Figure 2.1f

Infrastructure Design Review - Turbine 06

Bhlaraidh Wind Farm Extension S36C Varied Development

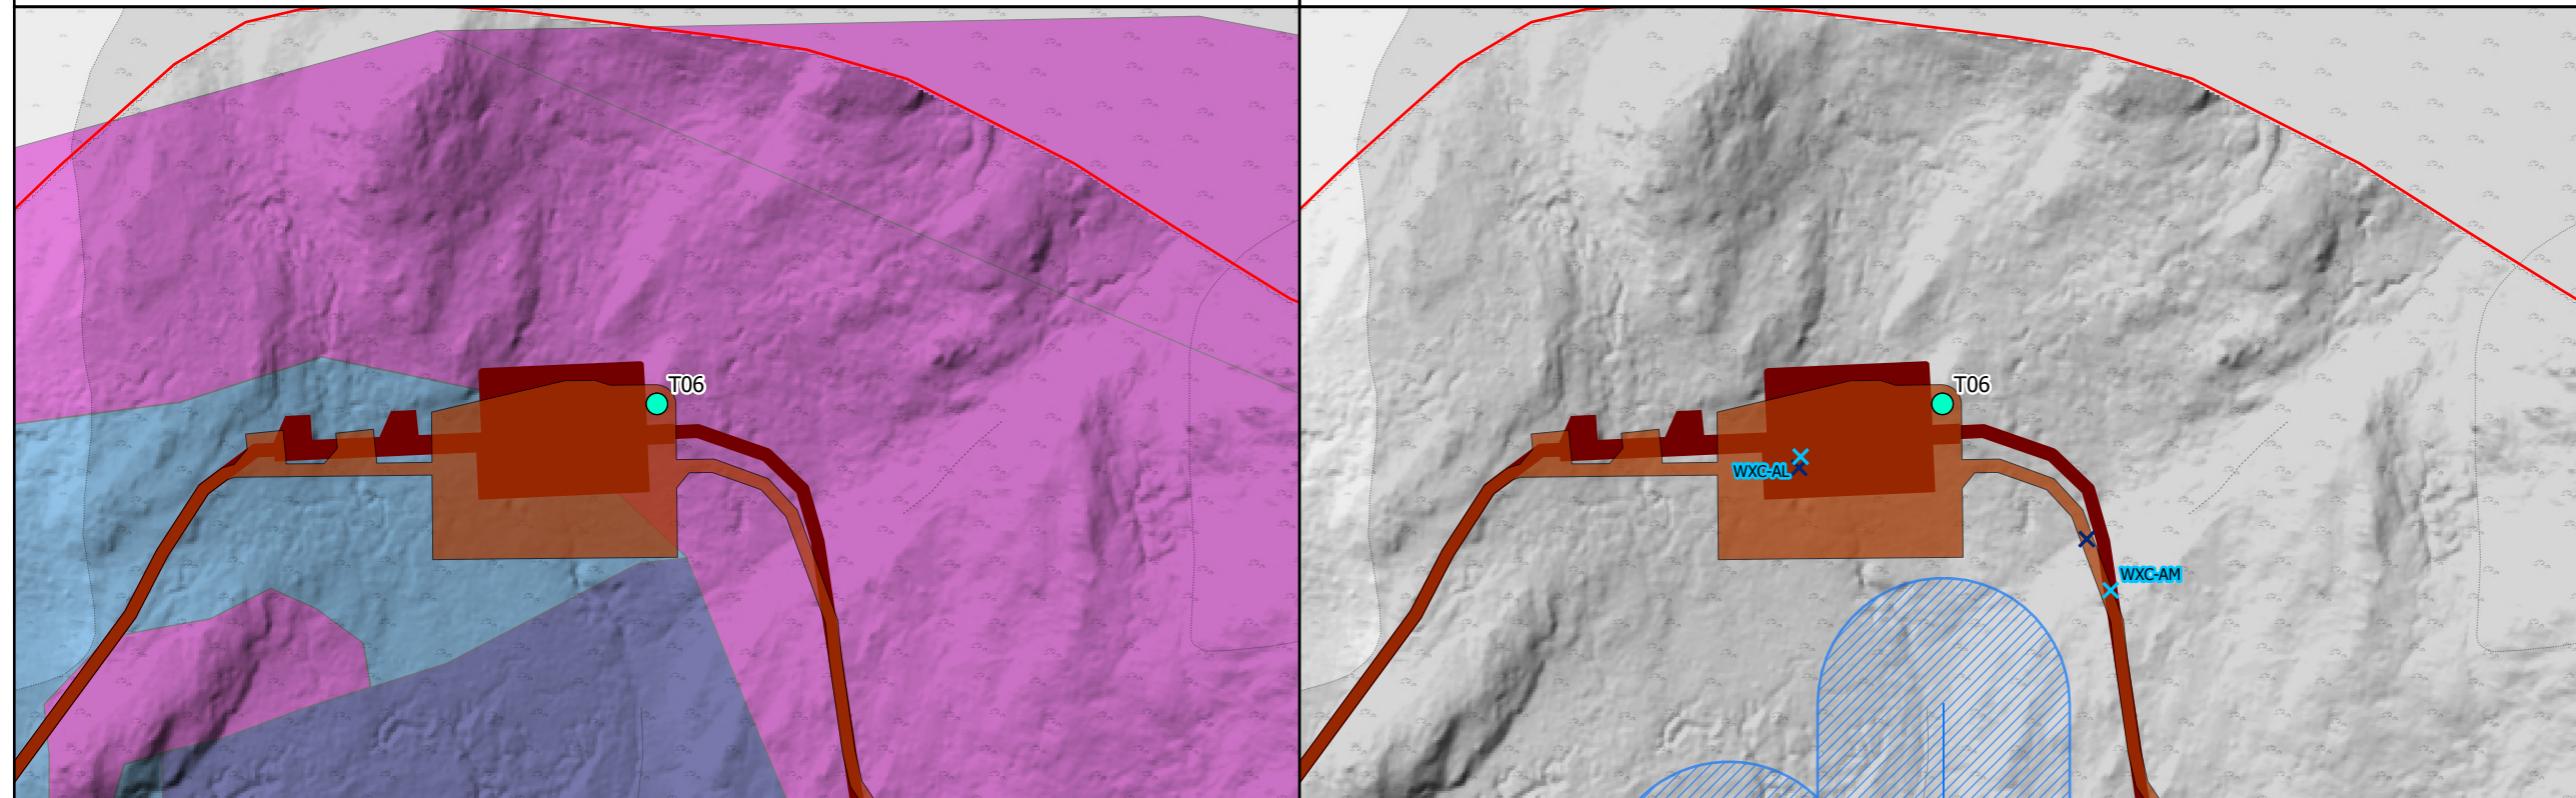
Engineering: The hardstand size has been increased on the shallowest gradients to reduce earthworks.

Geology Impacts: The use of larger turbines requires for hardstands to be used with a greater surface area to those contained within the current consent. This introduces the requirement to construct infrastructure in some areas of medium depth peat. The increased hardstand size fits within the current consented 50m micrositing buffer. There is an opportunity to improve the site tracks at both ends of the hardstand for constructability and to avoid peat pockets. There is no impact on the proposed HMP peatland restoration area.

Ecology Impacts: As the turbine location has not changed the impact is caused by the need to construct larger infrastructure. There is marginally less impact to the Wet Heath (M15c) and a greater area of Blanket Mire (M17/M17a/M18a/M19a) taken by the constructed hardstand.

Hydrology Impacts: The proposed location is outside the 50m water buffers.
